STATE OF OREGON
WATER RESOURCES DEPARTMENT

REQUEST FOR WRITTEN APPROVAL TO USE CONSTRUCTION METHODS NOT INCLUDED IN THE RULES AND REGULATIONS PRESCRIBING GENERAL STANDARDS FOR THE CONSTRUCTION AND MAINTENANCE OF WELLS IN OREGON

Well Constructor: Austin Well Drilling

- (6) A diagram showing the pertinent features of the proposed well design and construction (attach additional sheet if necessary):

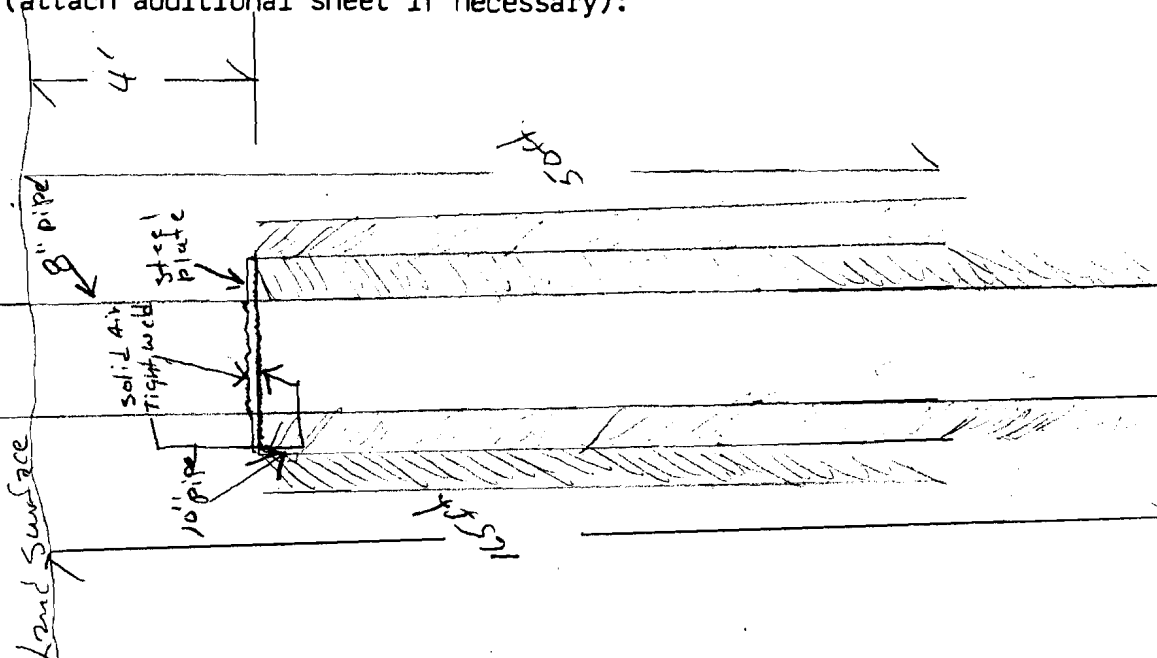
(4) The unusual conditions existing at the well site: We have a 10"

Casing sealed to 50 ft. with cement grout - with a 8" Liner
with a Drive Shoe to 165 ft. It is cemented between the 8" & 10" to 165

I would like to cut the 10" casing off below Land
Surface about 4 ft. and weld a solid steel ring around
The 8" casing to the top of the 10" casing making a
Positive between the 8 in. & 10 in casing - This would allow
The installation of a pitless adapter on the well

4-30-82

Approved by:
